Delegated Report

Householder Planning Application

Planning Application No: 20231312

Location: 7 Denesway Meopham Gravesend Kent

Proposed two storey side extension

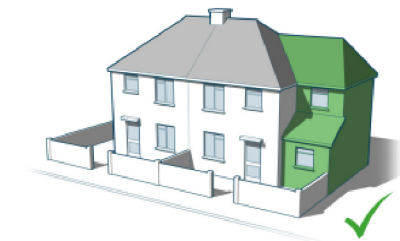
As originally submitted the proposed two storey side extension was not a subservient addition as it was to be built in line with the main front wall of the dwelling and would not have been set back from it. Whilst it was considered acceptable for the ground floor element of the side extension to project forward of the front wall as that was at ground floor level and there are other examples of single storey front additions in the road such as at the neighbouring semis to the west at nos. 3 & 5, at a minimum the first floor level of a two storey side extension should be set back from the main front wall in order to be subservient. As well as the front wall not being set back, the ridgeline of the extension would also not have been set down from the ridgeline of the host dwelling. With the extension not set back or set down, the proposed two storey side extension would therefore have not been subservient to the host dwelling and would also have impacted on the symmetry of this pair of semi-detached dwellings.

In its revised form the extension has now been set back from the main front wall of the dwelling by 1m and the ridgeline would be set down by 1.4m. Its width at first floor level has also been reduced so that it would now be 2m in width. With these changes the proposed two storey side extension would be extremely subservient and in keeping with the scale of the host dwelling.

In respect of other factors the eaves line would be in line with the eaves of the host dwelling, the width of the extension at ground and first floor would not exceed half the width of the host dwelling. The ground floor element of the proposed two storey side extension that would project forward of the main front wall is considered acceptable as stated given that it is at ground floor level and there are other examples of forward projections at ground floor level in the street; its pitched roof form would be in keeping with the host dwelling and form part of the proposed porch extension is covered below.

Although the proposed two storey side extension would reduce the gap which currently exists between the flank elevation of no. 7 and its boundary line to the west, given that the adjoining pair of semis nos. 3 & 5 are built in close proximity to their side boundaries of 1.4m and that the proposal would leave a gap of 1m at ground floor level and 1.6m at first floor level to the boundary line, it is considered that the reduction in the gap to the side of the dwelling would be acceptable in this case.

The hipped roof design would not reflect the roof of the main property given that the host dwelling has a gable end however, given the very modest nature of the extension in this case, whilst not ideal this is not considered so significant to justify a refusal and it does help aid the subserviency of the extension.

The first floor level window on the front would respect the proportions and style of windows elsewhere on the front elevation of the host dwelling. The two high level windows in the flank which were previously proposed and considered unacceptable have been removed. The rooflight in the flank roof slope is acceptable in size and appearance and would be to serve light to the first floor level not serve a loft conversion. In the rear elevation the proposed window in the rear of the side extension would replicate the existing window in the rear elevation. The altered window to large glazed area with Juliet balcony is considered acceptable as although not in keeping with the fenestration in the rear elevation, it is at least in the rear elevation and would not be publicly visible.

In respect of the proposed two storey side extension element of the proposal in its revised form it is now considered a very modest and subservient addition which would be in keeping with the scale and character of the host dwelling and would respect the symmetry of this pair of semi-detached dwellings and would not cause any harm to the character and appearance of the streetscene.

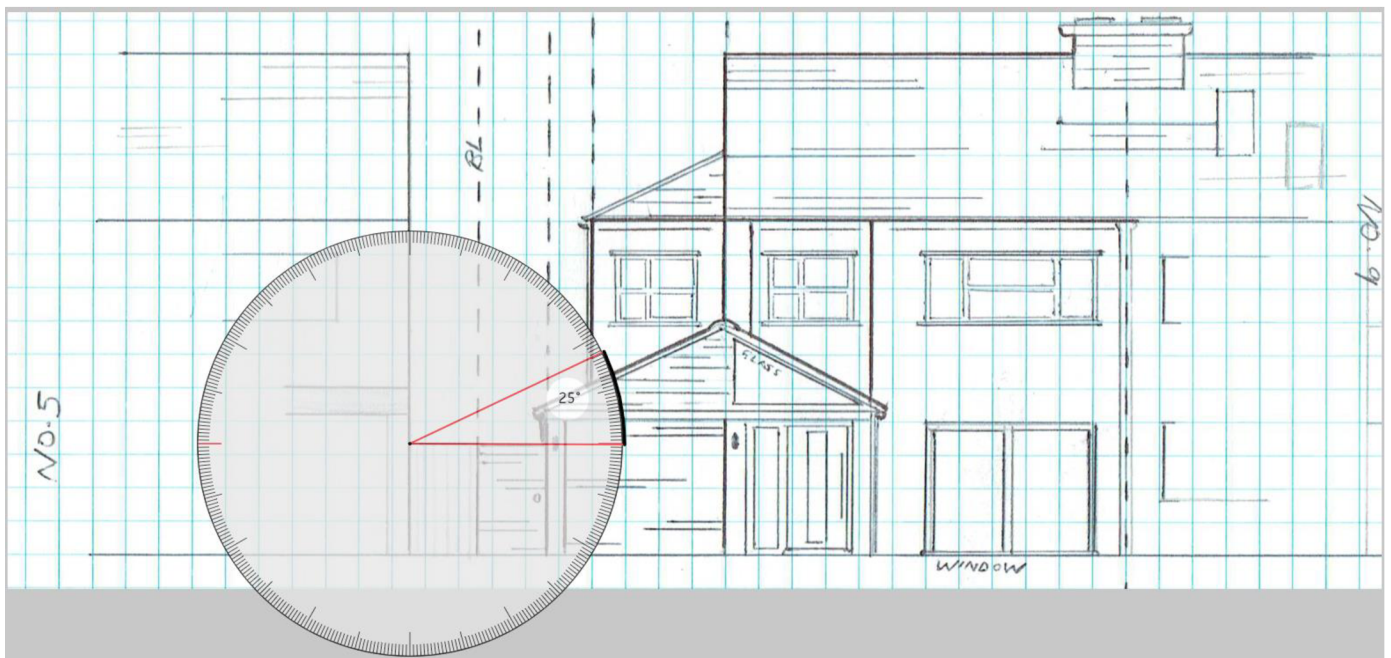
The new or re-ordered bedrooms would be as follows (with the numbering as shown on the proposed plans):

Master Bedroom – 13 sq. m/3.4m - meets minimum area and width for a double bedroom;

Bedroom 2 – 7.6 sq. m/2.3m - meets minimum area and width for a single bedroom;

Bedroom 4 – 8.1 sq. m/2.4m - meets minimum area and width for a single bedroom;

Bedroom 1 – 12.3 sq. m/3.2m wide – meets minimum area and width for a double bedroom;

Bedroom 2 – 7.4 sq. m/3m wide – is under the minimum area for a single bedroom by 0.1 sq. m but meets the minimum width;

Bedroom 3 – 10.3 sq. m/2.29 wide – meets the minimum area and width for a single bedroom but not a double bedroom.

Beds are not shown on the proposed floor plan to demonstrate whether the bedrooms are single or double bedrooms but given that bedroom 1 would exceed the minimum area and width for a double bedroom and that bedrooms 2 & 4 would exceed the minimum area and width for a single it is considered on balance that the amenity of existing and future occupiers of the dwelling would be protected in respect of bedroom sizes.
